Mr & Mrs Knee
60 Hawkins Crescent
Shoreham by sea
BN43 6TP

Existing Garage conversion
and extension

View A and B and sections C'C/D'D

Drg no - 104 rev B

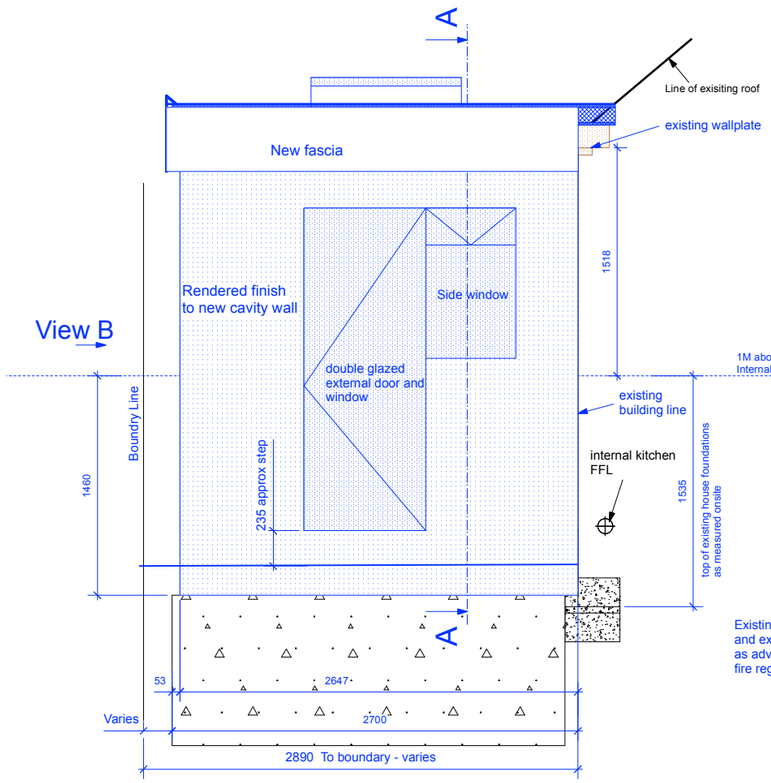
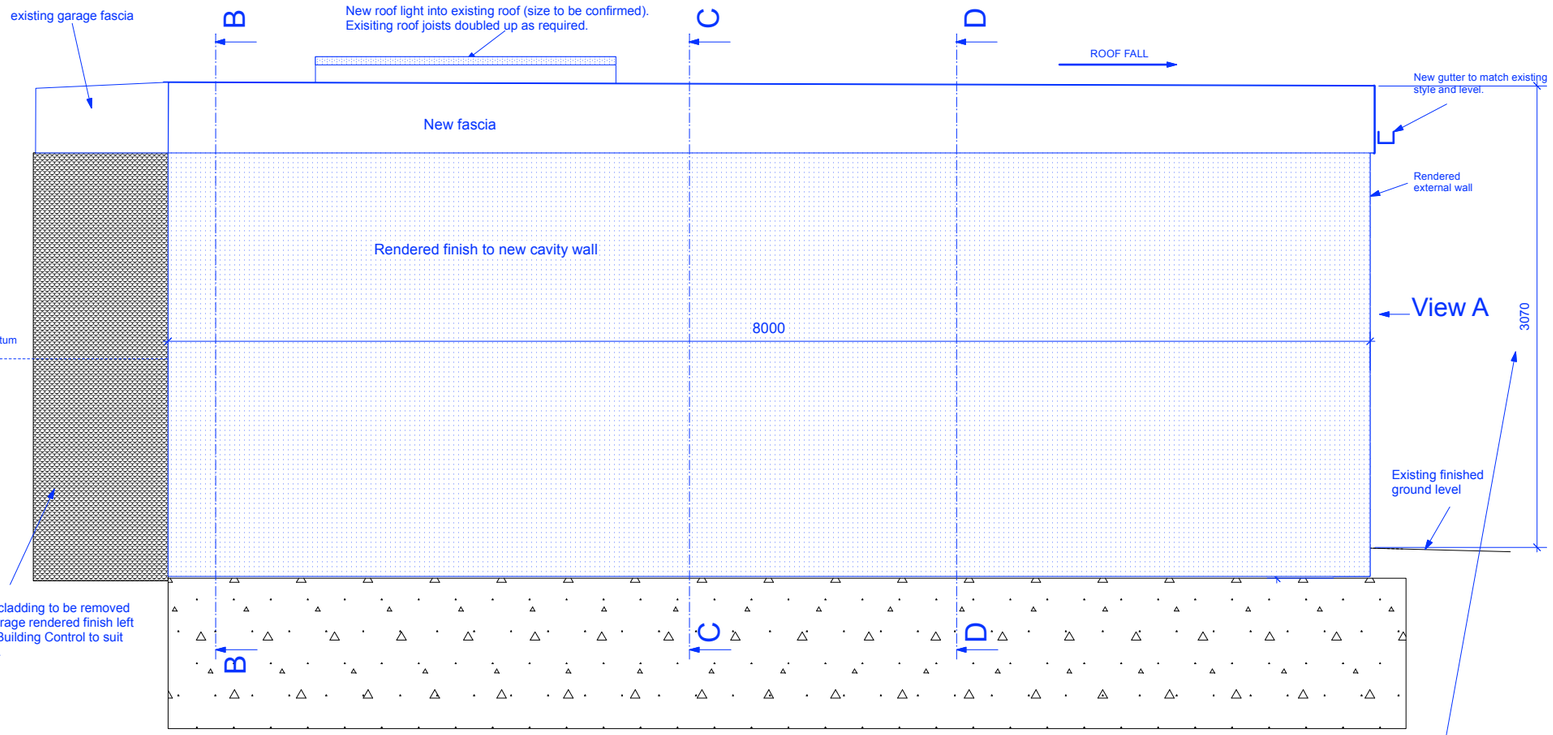
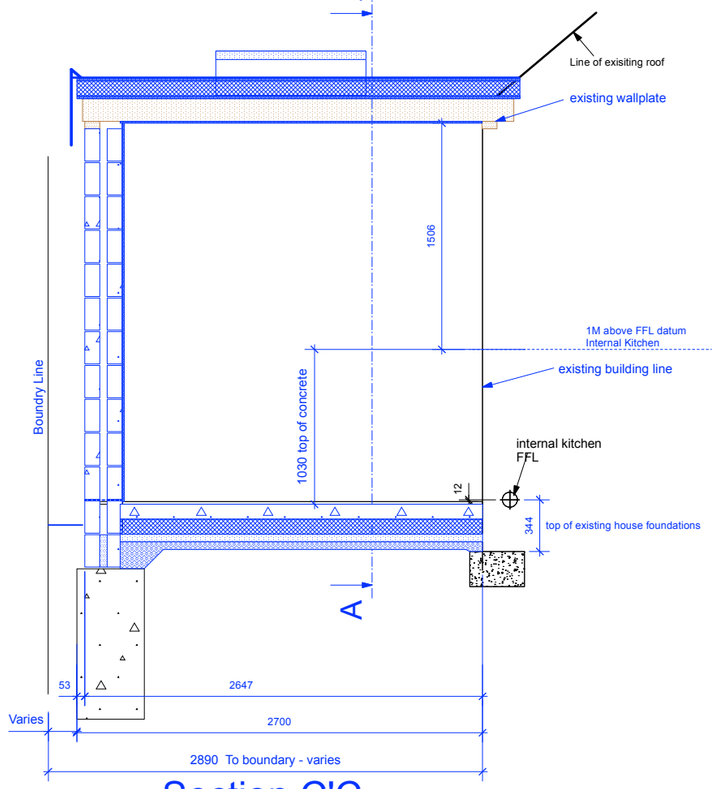
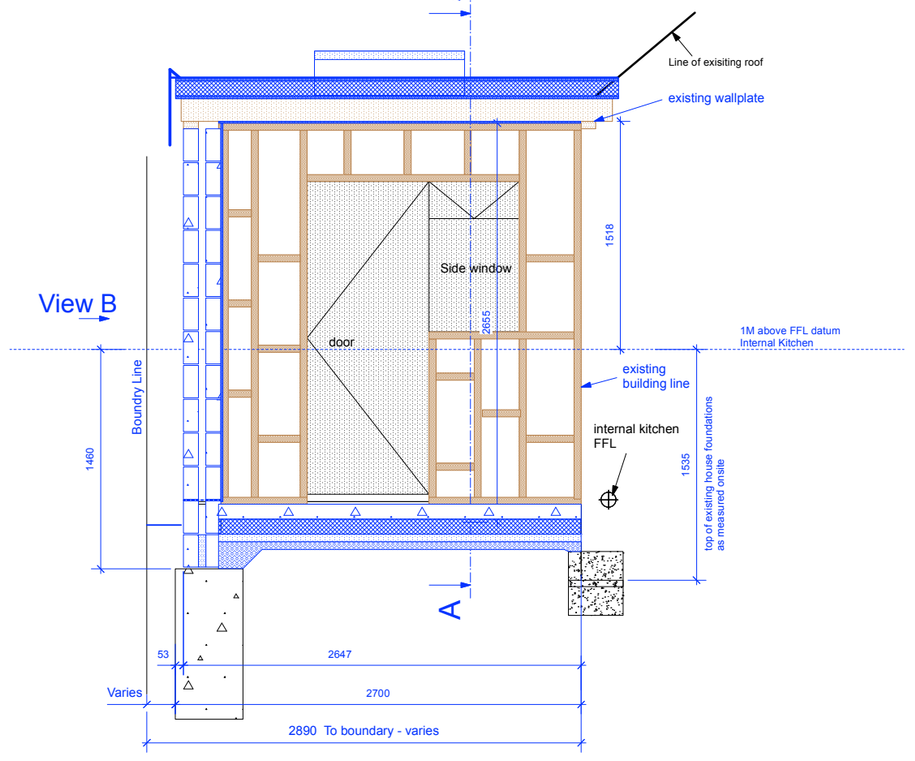
Rev B - As advised by Building Control external walls changed to blockwork construction with render and both new and existing roofs amended to warm roof construction, exisiting and new timber cladding removed - dimensions amended to suit. Insulation added to existing garage floor. 1.11.21
